SUBJECT: RADIOLOGICAL EFFLUENT TECHNICAL SPECIFICATIONS (RETS)  
FOR POINT BEACH UNIT NOS. 1 AND 2

We have completed our initial review of your October 7, 1983 submittal for the subject item. Comments regarding your submittal are contained in the enclosure to this letter. These have been discussed briefly with Mr. Krause of your staff.

OCTOBER 7, 1983 RETS SUBMITTAL COMMENTS  
POINT BEACH UNITS 1 AND 2

TABLE 15.3.9-1 (CONTINUED)

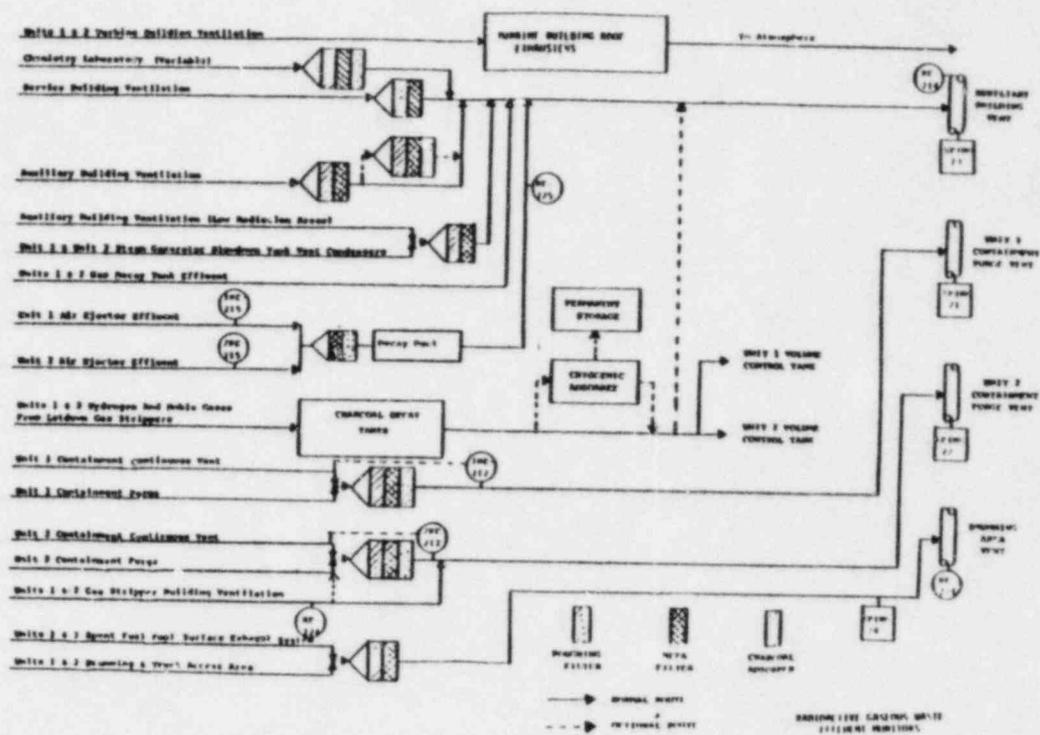
**Reviewer's Comment**  
1. At the plant visit we were informed there are both H<sub>2</sub> and O<sub>2</sub> monitors. However, the monitors are not identified in the submittal. The following briefly describes their situation:  
"The waste gas system is not designed to withstand an explosion and there are no recombiners. The system has a 2 psig positive pressure N<sub>2</sub> blanket. There is a gas analyzer that works in manual but does not work well in automatic sampling. If the analyzer is inoperable, grab samples are taken and analyzed at the same frequency as the analyzer. Of the twelve tanks sampled, three are waste gas decay tanks and sampling frequency is once per week.  
The instruments on the analyzer have the following ranges:  
H<sub>2</sub> 0 - 100 vol. %  
O<sub>2</sub> 0 - 5 vol. %  
and are calibrated with the following standards:  
H<sub>2</sub> 100 Vol. %  
O<sub>2</sub> 2 and 5 vol. %.

1. Include the analyzer in Table 15.3.9-1.
2. Use the gas analyzer only to sample the in-service gas decay tank to ensure O<sub>2</sub> concentrations are < 2 vol. % O<sub>2</sub>. This ensures the valved-out tanks are < 2 vol. % O<sub>2</sub>. This may require plant modifications to add manual valving from each of the three decay tanks to the gas analyzer. This would permit the analyzer to operate in a manual mode and eliminate the problems that occur from using the equipment in auto.
3. Include the calibration gas standards in a footnote to Table 15.3.9-1.
4. Include an action statement to sample and analyze every four hours whenever gases are being added to the in-service tank in the event of loss of the gas analyzer.
